LOT GRADING PLANS APPROVED
SUBJECT TO REVISIONS NOTED
MAY 28 2012
ENGINEERING DEPARTMENT
TOWN OF WHITBY

CLIENT
ZANCOR HOMES

PROJECT/LOCATION
OLDE WINCHESTER
BROOKLIN, ONT

DRAWING
SITE GRADING PLAN

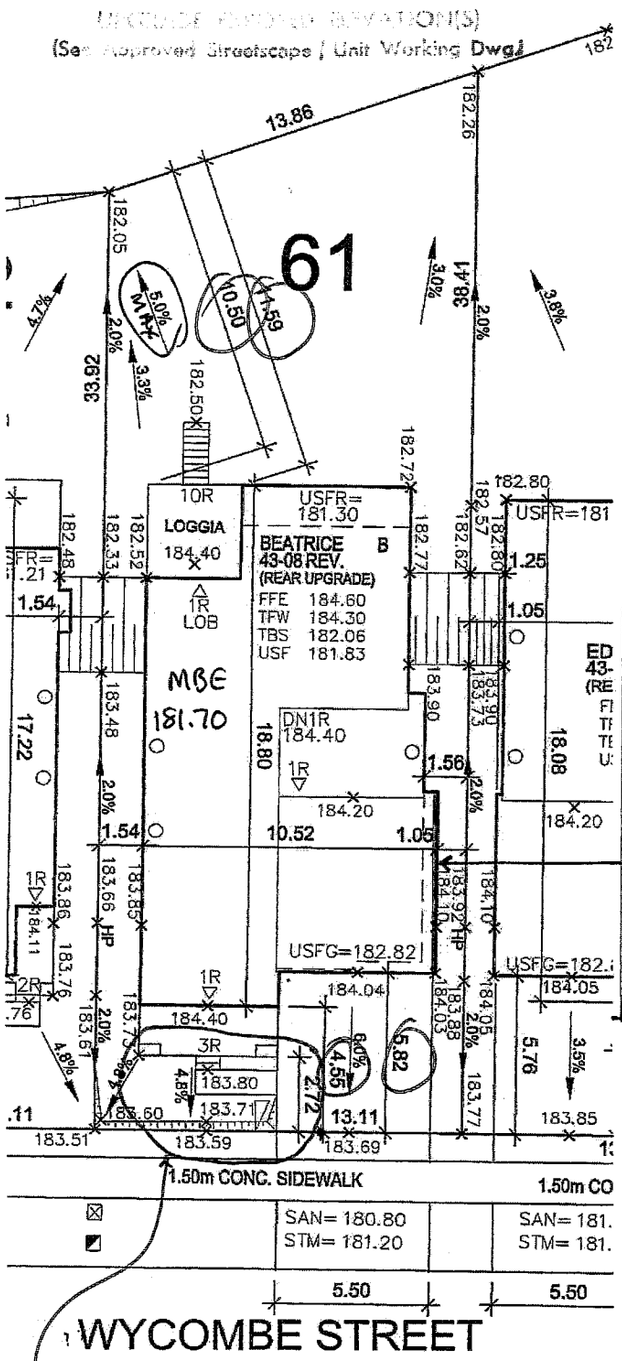
Framing not to begin prior to certification of foundation control elevation for:
[ ] TFW
[X] MBE
[ ] max USF
as per T.O.W. Standard No. 303.10

$t_{FF} = 24'10"$
$= 7.60 + 0.72$
$= 8.32$

INCLUDE ADDITIONAL ELEVATION(S)
(See Approved Streetscape / Unit Working Dwgs)

SEE ATTACHED ADDENDUM

NOTE: PROVIDE MINIMUM 45 MINUTE FIRE RESISTANCE RATING TO EXPOSING BUILDING FACE AS REQUIRED BY OBC 9.10.15.5(2)(b)
